APPLICATION NO.	FILING DATE	FIRST NAMED INVENTOR	ATTORNEY DOCKET NO.	CONFIRMATION NO.
10/695,295	10/28/2003	Joseph A. Gonzales	A-2966-AU	4188

Office Action Summary

DETAILED ACTION

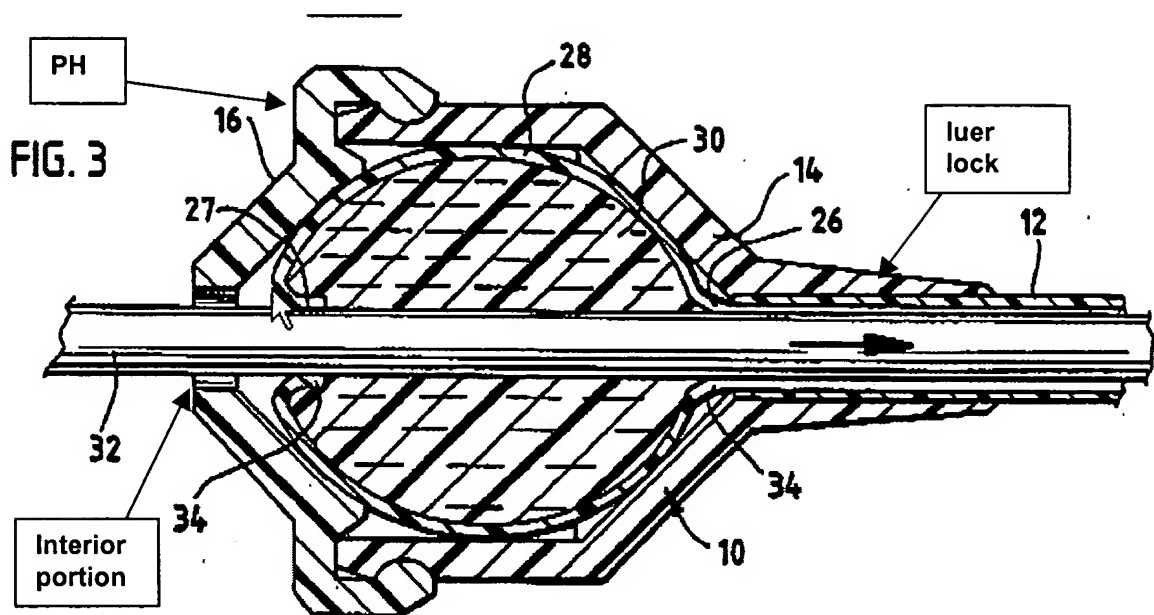
Gravener et al and Weinstein et al each disclose a surgical valve (Gravener 12, Weinstein 10) having an axis extending between a proximal and a distal end comprising a housing including a proximal housing portion (Gravener 26, Weinstein PH as shown in fig. 3 above) and a distal housing portion (G18, W14) cooperating with the proximal housing portion (G26, Weinstein PH) to define a gel cavity (G42, W30), a seal material disposed in the gel cavity, the seal material including a gel having non-compressible characteristics; a proximal guide tube (G22, W16) extending axially proximally from the proximal housing portion; the proximal guide tube facilitating insertion of a surgical instrument into the seal material, a distal guide tube (G20, W12) extending axially distally from the distal housing portion, the distal guide tube facilitating retrograde insertion of the surgical instrument (G44, W32) into the surgical seal;

Furthermore, as to claim 2, Weinstein et al discloses a luer lock (see fig. 3 above) coupled to the distal guide tube (12), the distal guide tube (12) being included within the luer lock.

Moreover, both the prior art references teach that wherein the proximal guide tube (G22, Weinstein 16) includes exterior portions (G22, W18) extending proximally of the proximal housing portion (G26, W PH); and interior portions (G34, W as indicated in fig. 3 above) extending distally of the proximal housing portion (G26, W as shown); and wherein the seal material (G42, W30) defines an axial channel through the gel; and the proximal guide tube (G22, W32) contacts the seal material around the axial channel at the proximal end of the valve (see G figure 7, W fig. 3); and wherein the seal material and the first housing portion form a subassembly free of a circumferential seal between the seal material and the first housing portion; and subassembly to form a circumferential seal between the gel and the first housing portion the proximal guide tube applies a force to the seal material in the subassembly to form a circumferential seal between the gel and the first housing portion (see G figure 7, W fig. 3).
